INSPECTION REPORT
Sedimentation Structure
TPF-C
Kayenta Mine
Navajo County, Arizona
for
PEABODY COAL COMPANY

Dames & Moore
10139-011-22

SITE PLAN
TPF-C

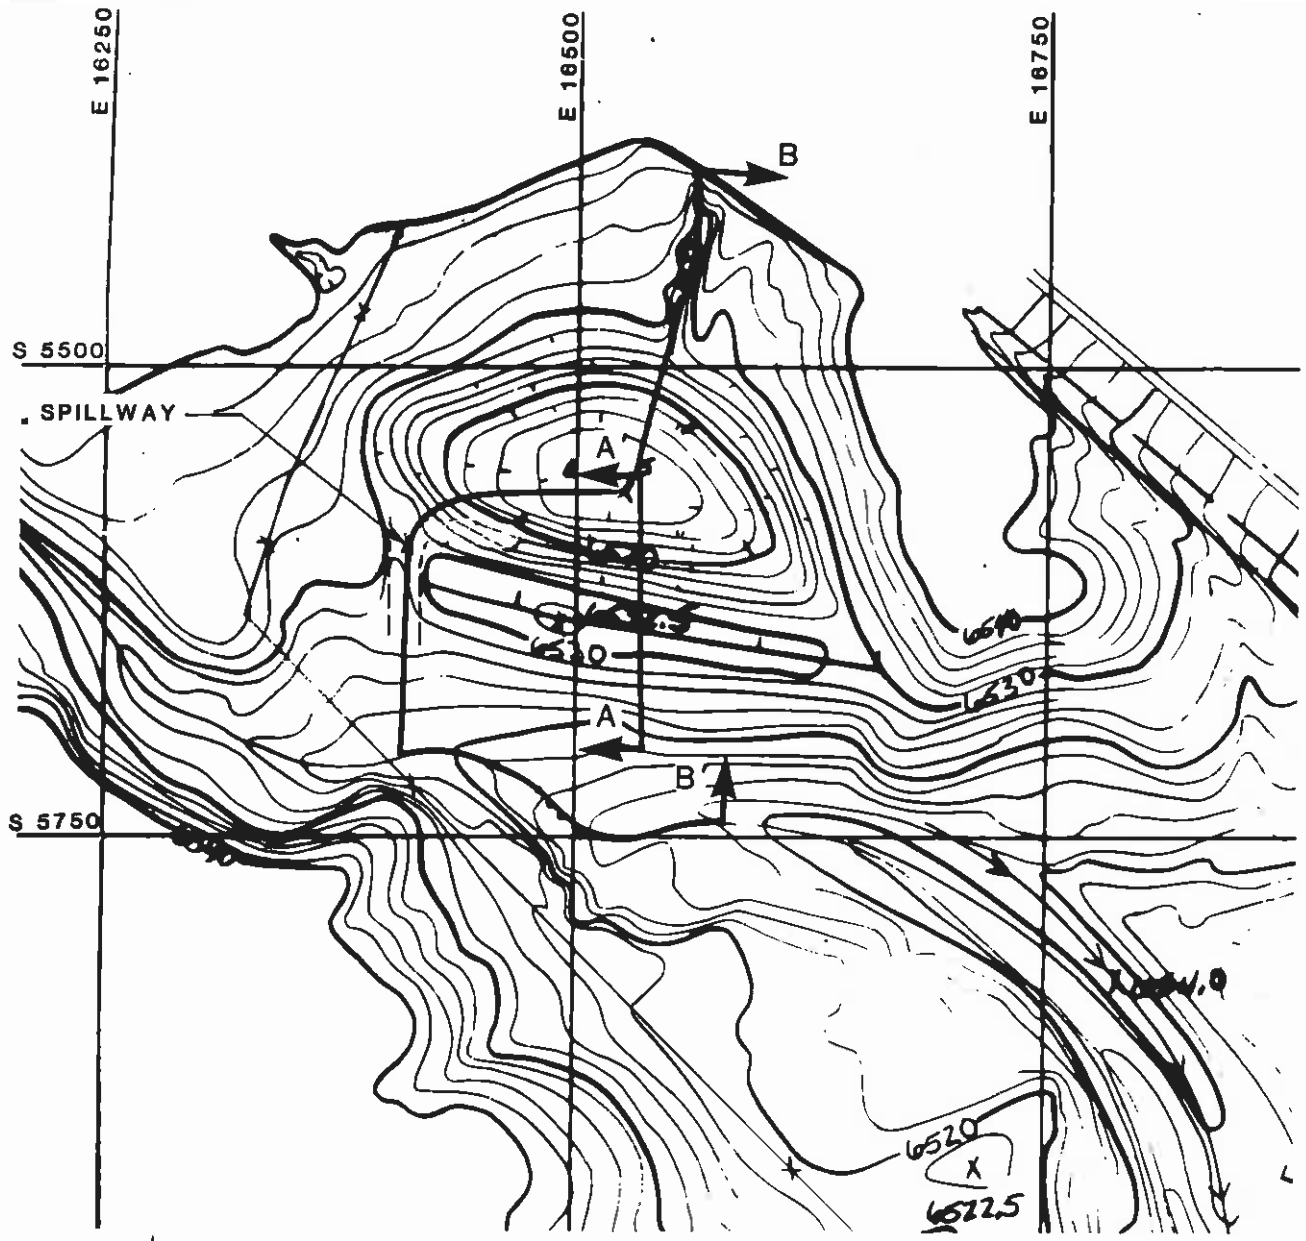
The storage capacity and spillway capacity of Structure TPF-C are adequate; however, the spillway does not have an outflow channel or adequate erosion protection. A trapezoidal outflow channel should be constructed along the alignment B-B' shown in Plate 1. The channel profile is shown in Plate 4 and the required dimensions are shown in Plate 5. Both the spillway and outflow channel should be protected against erosion using geotextile and gravel as shown in Plate 5.
